DESCRIPTION

Aperia has released a new torque specification and Grade 8 hex bolt to enhance reliability.

Figure 1. Updated bolts in teal

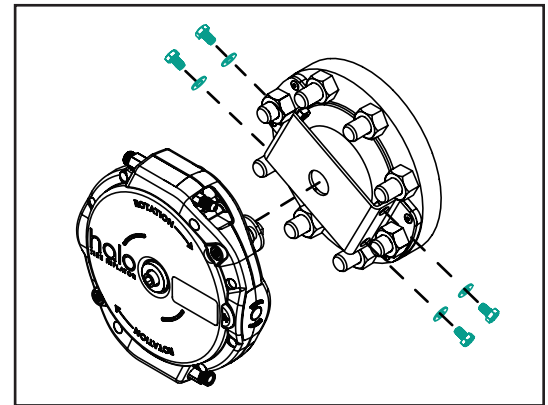
The Grade 8 hex bolts replaces the existing Grade 5 hex bolt during the installation of the Halo device (see Figure 1). All existing, and new bolts should now be torqued to the 20 +/- 2 ft-lb specification, as opposed to the previously communicated 15 +/- 2 ft-lb setting.

All hex head bolts shipped by Aperia to fasten the Halo onto the bracket, shown in Figure 1 and detailed in Table 1, are affected by this update.

- The Grade 5 hex bolts should be torqued to 20 +/- 2 ft-lb during the next preventative maintenance.
- The Grade 8 hex bolts with nylon patch should be torqued to 20 +/- 2 ft-lb during the next preventative maintenance.
- All future Halo shipments will include Halo User Manual (IN-100UM_R03), which includes the updated torque specification.
- Bolts should be checked during recommended maintenance, as outlined in the Halo User Manual (IN-100UM_R03).
